# Imray Correction Notice ICA301

28 February 2024

## Chart **A301** WGS 84

*Edition 2006*

Block correction for A301 (Plan B)  
ILNW 453/18

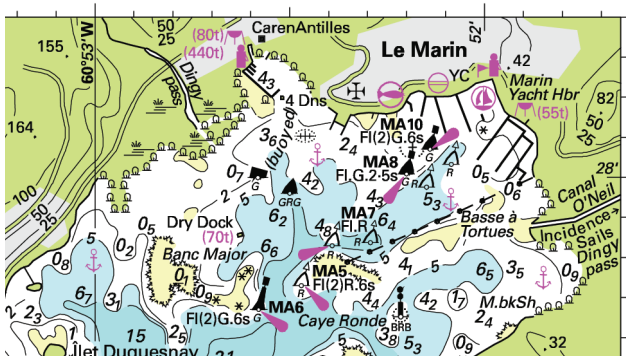
#### 17 Cul-de-Sac Marin (Plan B)

Insert accompanying block correction centred on 14°27'·99N 60°52'·41W (Doyle/Street 9/2018) (ILNW 453/18)
